**Title: Stage 1 DMURS Quality Audit,
Incl. Stage 1/2 Road Safety Audit
For;
Proposed Development at Lehaunstown, Cherrywood.**

Client: Dun Laoghaire Rathdown County Council.

Report reference: 2232R01

VERSION: FINAL (21-6-2024)

Drawing 232250-PUNCH-XX-XX-DR-C-0461 Rev P04, Link Between Street 1 and Street 2.

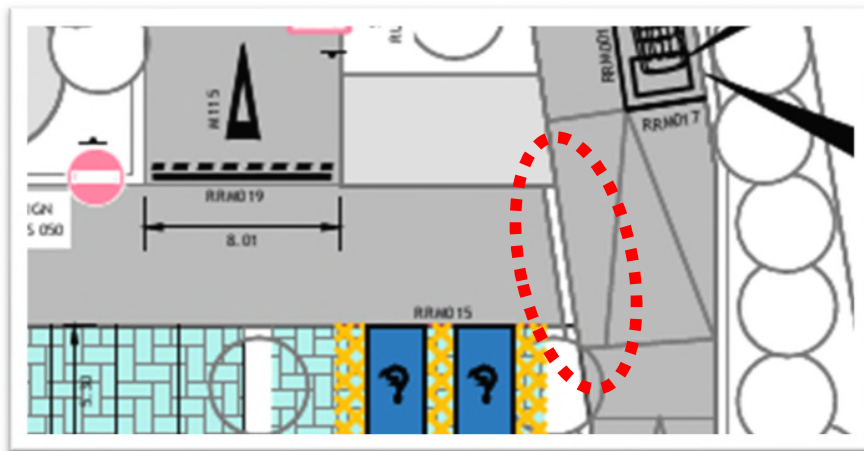
There is a wall/structure between Street 1 and Street 2 close to the entry to the basement. It is unclear what height this wall is to be. A low level wall (kerb) may not be seen by drivers and they may travel over it if unfamiliar with the area and a low wall may be climbed over by children leading to falls.

It is recommended that a suitable height wall be provided.

Drawing 232250-PUNCH-XX-XX-DR-C-0461 Rev P04 & 232250-PUNCH-XX-XX-DR-C-0602 Rev P02,
Entrance to basement.

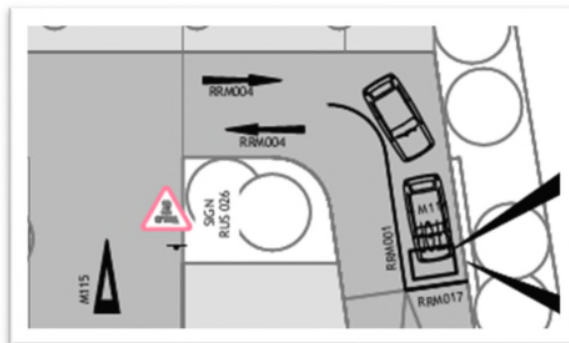
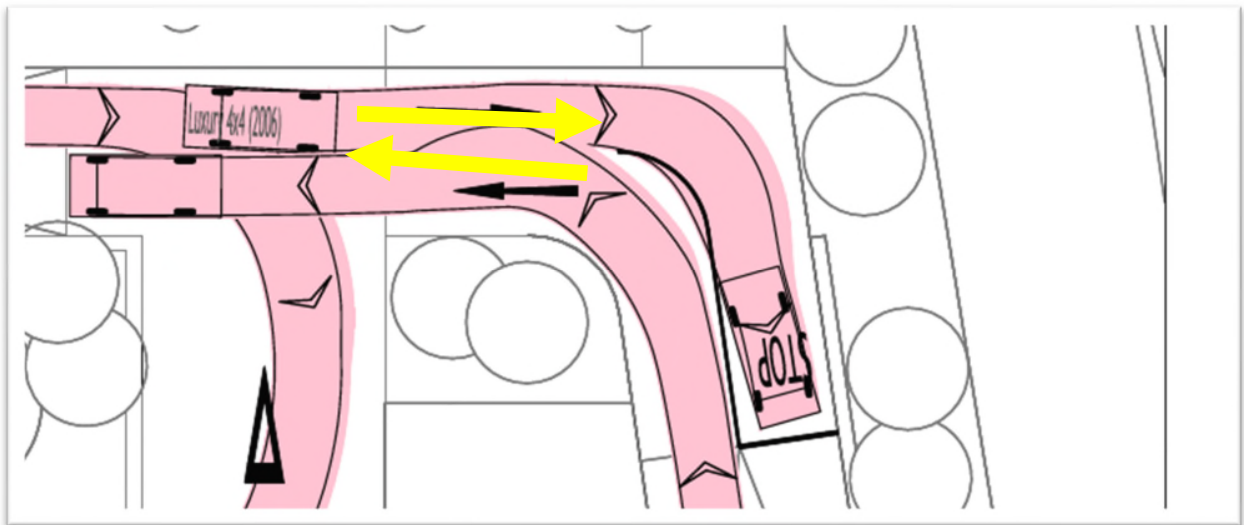
There is a risk of side-swipe collisions of vehicles entering and exiting the car park if a queue forms as far as the tight bend when a vehicle is exiting.

It is recommended that a suitable width of carriageway be provided for cars to pass without overlapping swept paths when waiting at the stop line of the signals for the basement car park.

Drawing 232250-PUNCH-XX-XX-DR-C-0601 Rev P02,

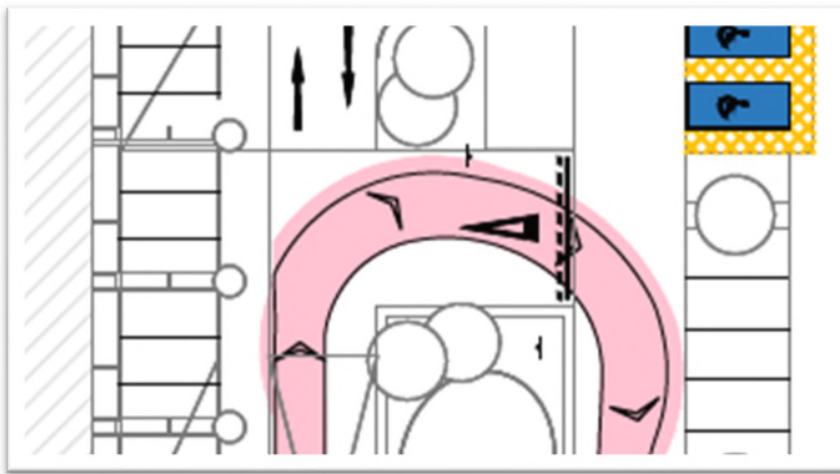
The entrance and exit of the one-way sections at Street 2 are very wide and have proposed yield control. This could lead to higher turning speeds and more severe collisions if a vulnerable road user is struck. The wide areas could also lead to informal two-way use by some residents. A wider area is needed for the swept path of refuse vehicles however these are only occasional vehicles.

It is recommended that the widths be minimised and overrun areas be provided for occasional larger vehicles. Stop control should be provided to ensure drivers check for pedestrian and cyclist activity.

Paragraph No. in Safety Audit Report	Problem accepted (yes/no)	Recommended measure accepted (yes/no)	Alternative measures (describe)	Alternative measures accepted by Auditors (Yes/No)
4.1	Y	Y		
4.2	Y	Y		
4.3	Y	Y		
4.4	Y	N	Widths to be retained to accommodate fire tender movements. Roadmarking controls (chevrons) proposed to manage cars and other small vehicles. High quality visibility will enable yield marking.	Yes
4.5	Y	Y		
4.6	Y	N	Roadmarking and/or kerb to be provided to manage vehicle movements.	Yes

Drawing 232250-PUNCH-XX-XX-DR-C-0603 Rev P02, Basement.

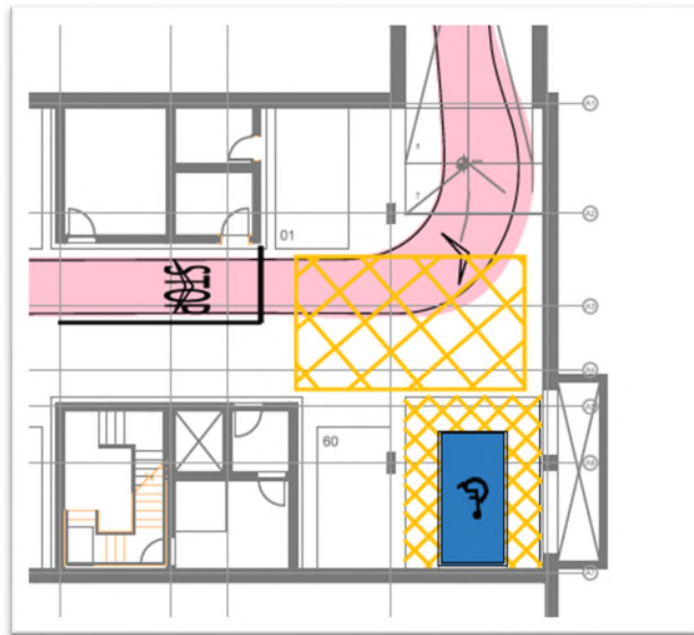
Users of the disabled parking space and spaces 01 and 60 will be within the shuttle signals. They could meet with incoming vehicles whose drivers do not expect oncoming traffic resulting in head-on collisions.

It is recommended that a detection system for these spaces be provided to stop incoming traffic.

Drawing 232250-PUNCH-XX-XX-DR-C-0603 Rev P02, Basement.

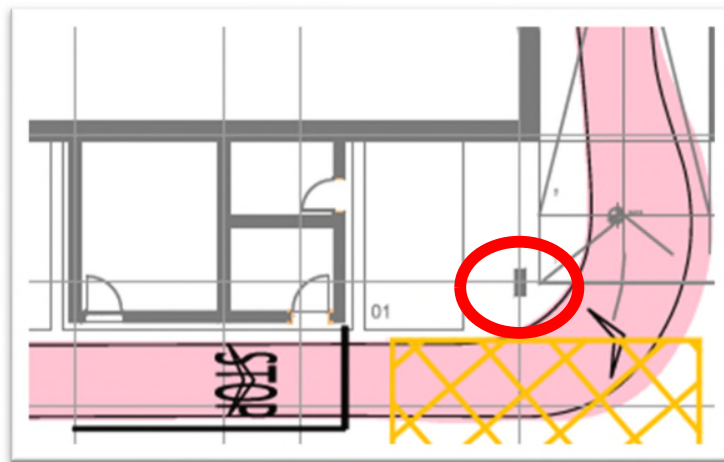
There is an exposed structural column at the base of the ramp. There is a risk that drivers may not see it leading to side swipe collisions and material damage of vehicles.

It is recommended that the column be relocated.

Drawing 232250-PUNCH-XX-XX-DR-C-0461 Rev P04, The Mall.

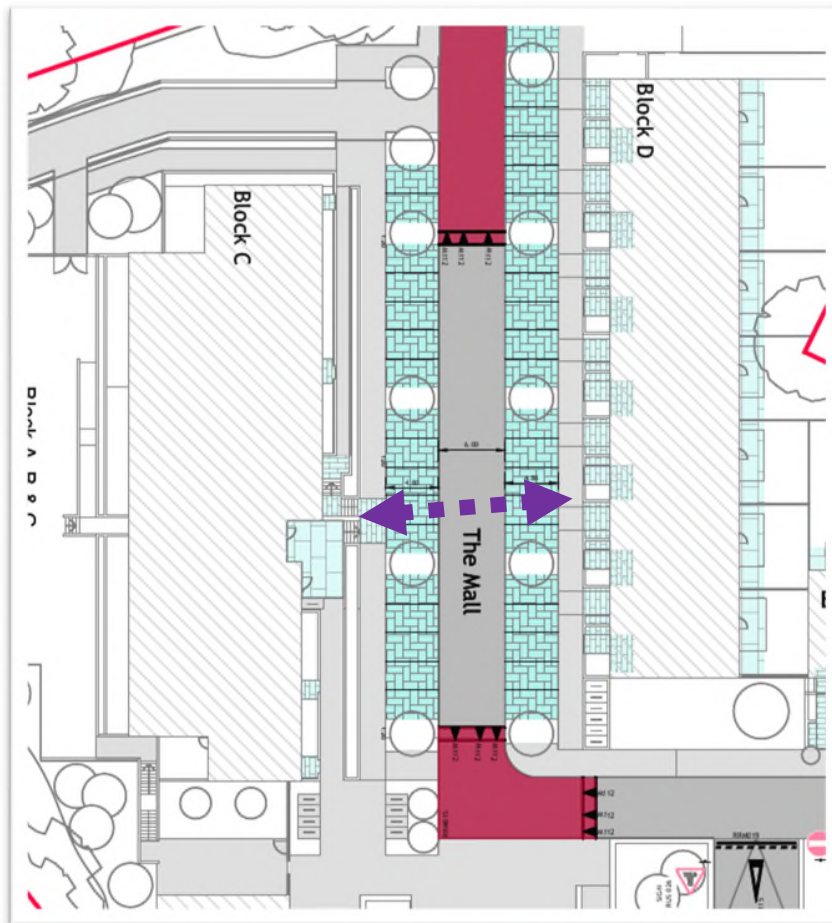
There is perpendicular parking on both sides of 'The Mall'. There is no direct area for pedestrians to cross between Block C and Block D except at either end.

It is recommended that the potential desire line in the centre of the blocks be assessed and a crossing area be provided if such a demand is predicted.

Drawing 232250-PUNCH-XX-XX-DR-C-0461 Rev P04, The Mall.

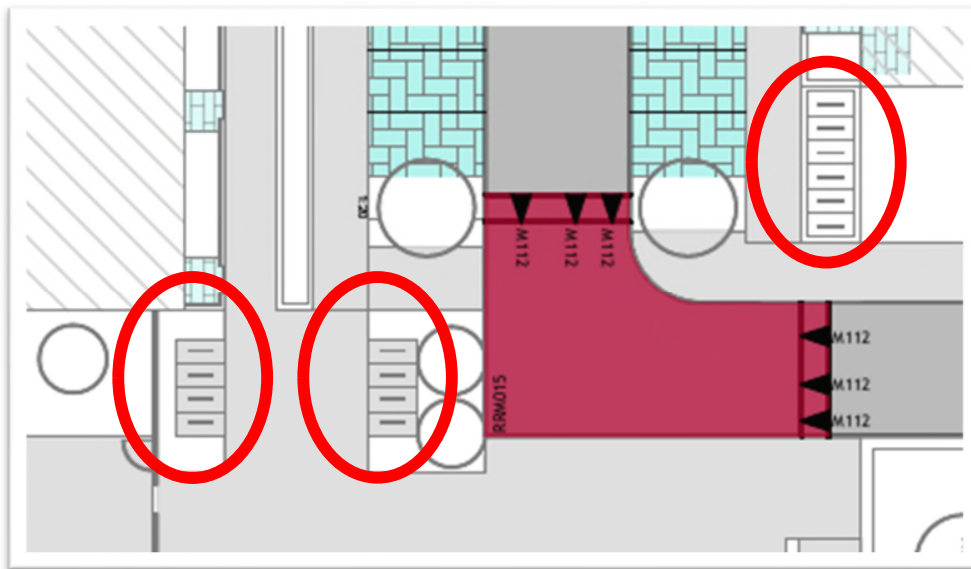
Cycle parking is shown on the surface level. It is unclear if there is any sheltered and secured parking. A lack of shelter can lead to a reduction in bicycle use and an increase in car usage.

It is recommended that a suitable proportion of sheltered and secure bicycle parking be provided.

Drawing 531-PD-01 Rev B, Landscape Design Plan.

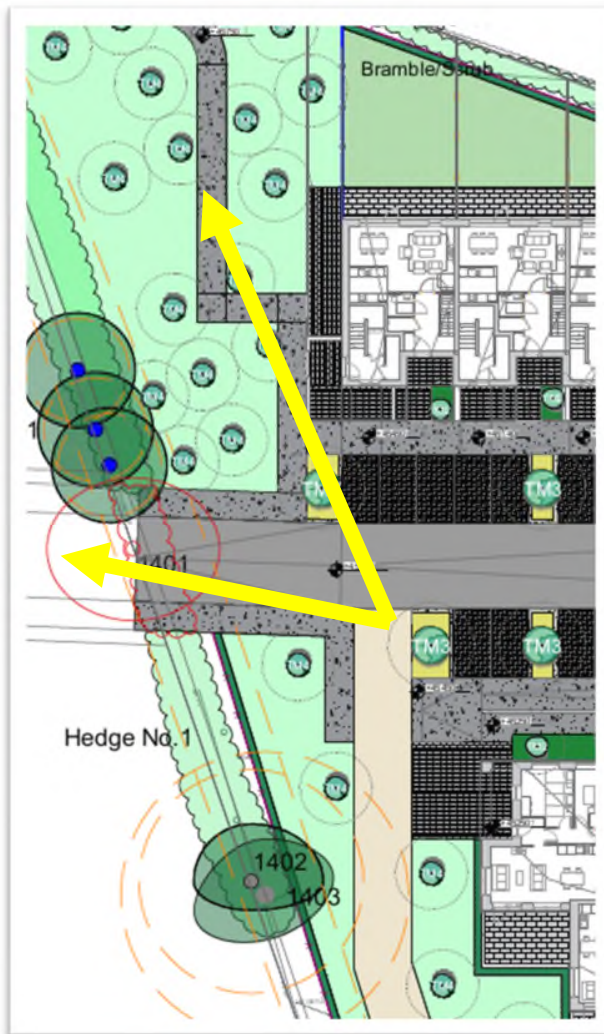
The proposed greenway terminates at The Mall. There is no further link for cyclists towards Lehaunstown Lane or to Grand Parade.

It is recommended that a continuity of cycle facilities to the adjacent road network be developed.
